寄件者: Tang Lok San <[REDACTED]>
寄件日期: 2026年08月11日星期二 15:02
收件者: tpbpd/PLAND
副本: Ivan Sze Yuet FUNG/PLAND
主旨: Re: S. 16 Planning Application No. A/YL-KTN/1257 - Departmental Comments
附件: AYL-KTN 1257 20260811.pdf

有關環境保護署對 A/YL-KTN/1257 的查詢

有關對古物古蹟辦事處 A/YL-KTN/1257 的查詢

Responses on DSD's Requirements / Reminders

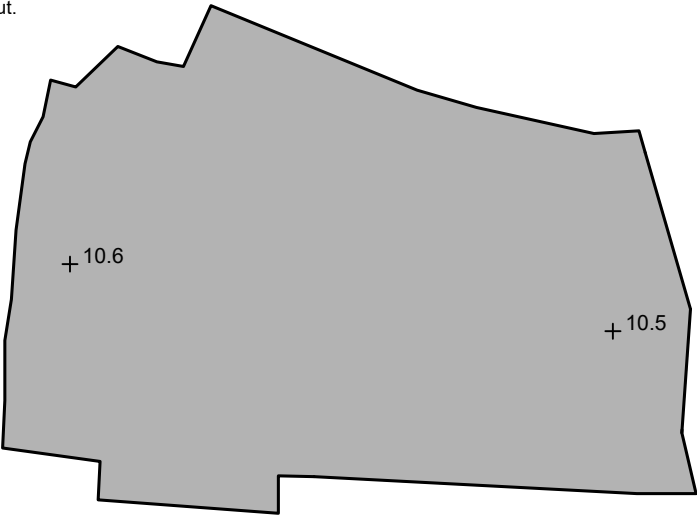
收悉 貴處對 A/YL-KTN/1257 申請的疑問，本人現書面回覆：

填土及平整方面，本申請之填土及平整的範圍請參考 **Appendix 4**。不會將整個申請範圍填到相同或相約的水平高度，會保留現有的地型。

填土及平整物料方面，申請地點現時已使用混凝土填高及平整約 **0.2** 米。申請人會在申請結束後根據規劃署及地政總署的要求將鋪地的物料打碎並運走，回復原來面貌，不會為該地造成長遠影響。

Original Site Level: +10.4 mPD
Existing Site Levels: +10.5 mPD - +10.6 mPD (About)
Material of Filling: Concrete
Proposed Use: Structures Building, Dog Outdoor Area, Parking Space and Circulation Space

* This Application is to regularized filling of land and no further filling of land will be carried out.

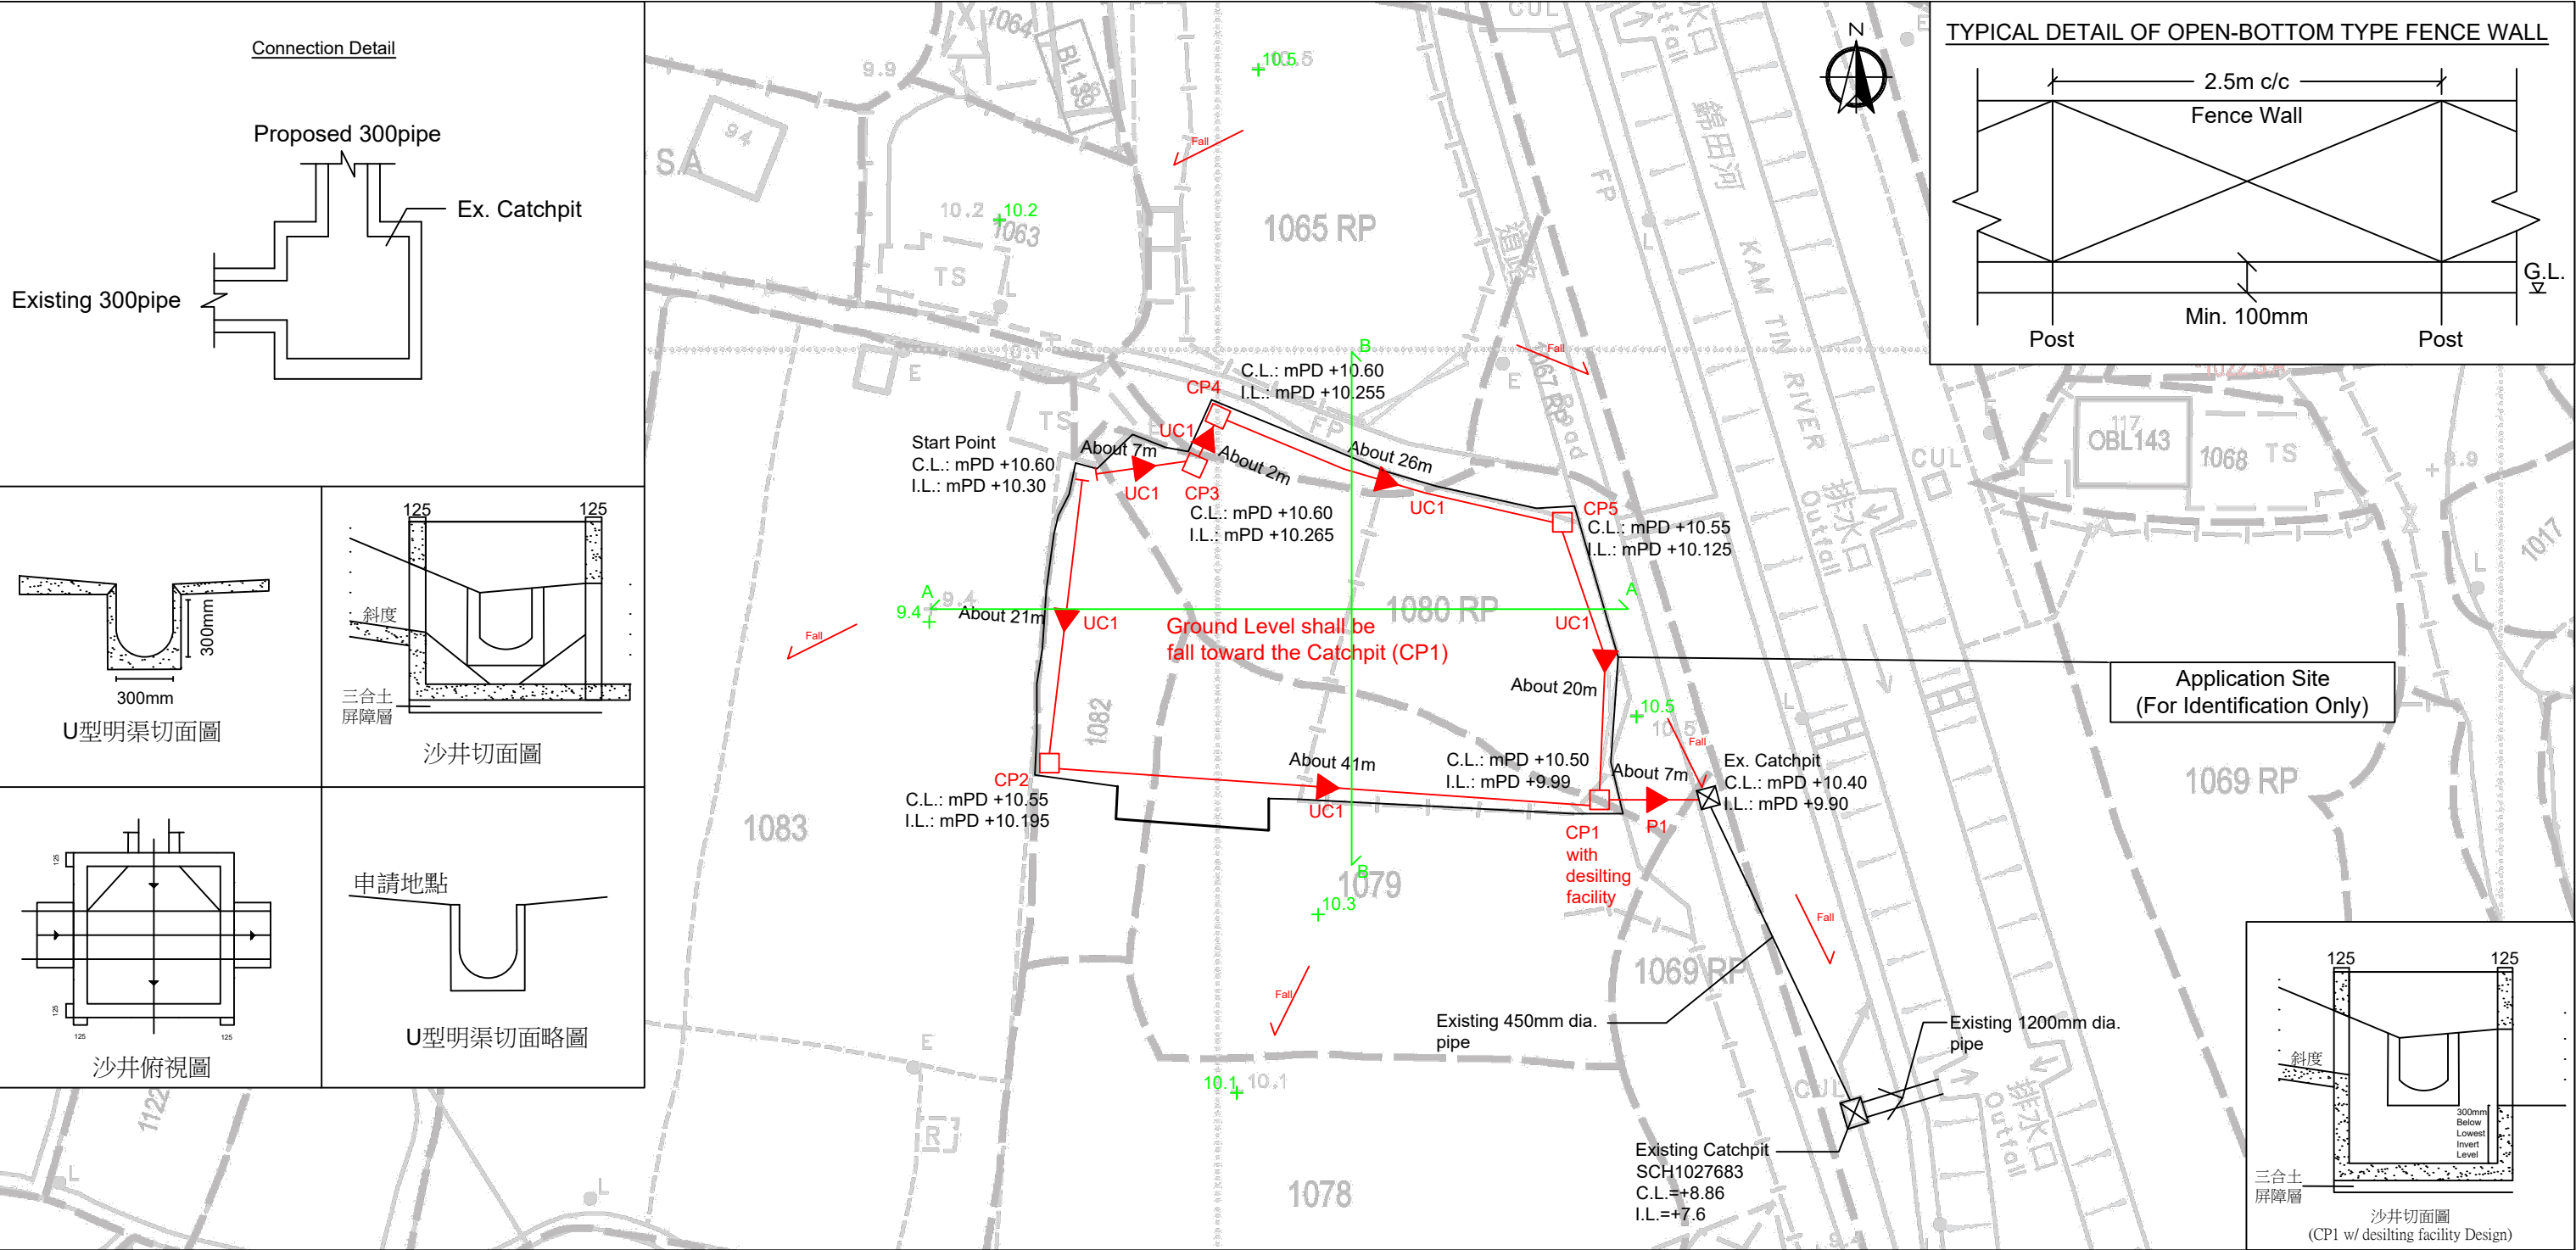
(6) The applicant should indicate the proposed and existing ground levels of the application site and ground levels of adjacent areas on the drainage plan.	Yes

(7) Cross sections showing the proposed drainage facilities and existing and proposed ground levels of the captioned site with respect to the adjacent areas should be given.	Yes

(8) The proposal should indicate how the runoff (the flow direction) within the site and from the adjacent areas would be discharged to the proposed drainage system.	Yes

(9) Sand trap or provision alike should be clearly indicated on the proposed drainage plan and provided before the collected runoff is discharged to the existing drainage facilities.	Yes

(10) The applicant should clearly indicate the full alignment of the discharge path from the application site all the way down to the ultimate discharge point (e.g. a well-established stream course/public drainage system).	Yes

(11) The applicant should clearly indicate the existing drainage facilities on the proposed drainage plan. Site photos of existing drainage facilities including the discharge point (e.g. existing local village drain and its downstream drainage facilities) should be provided in order to demonstrate the presence and reflect condition of the existing drainage system. Also, the applicant should provide site photo(s) to demonstrate size of the existing drainage facilities.	Yes

(12) Cover levels and invert levels of the proposed and existing drainage facilities should be shown on the drainage plan. Invert levels of drainage facilities at the upstream should be higher than that at the downstream. Also, gradients and sizes of the proposed and existing drainage facilities should be shown on the drainage plan.	Yes

挖掘方面，現場無需進行大型挖掘工程。而申請地點亦會在申請範圍四周進行小量挖掘工程，以便興建渠道，跟據現時的渠道計畫書，會興建約 **300** 毫米深及闊的渠道來收集表面流水，將水收集並已連接下游渠道（請參考 **Appendix 7**）。此新增渠道只會在因規劃申請所填土及平整的空間內進行，相信不會影響附近及下游的生態，附近的污染達至零污染，亦能保護地下具考古研究價值的範圍，希望 貴處諒解。
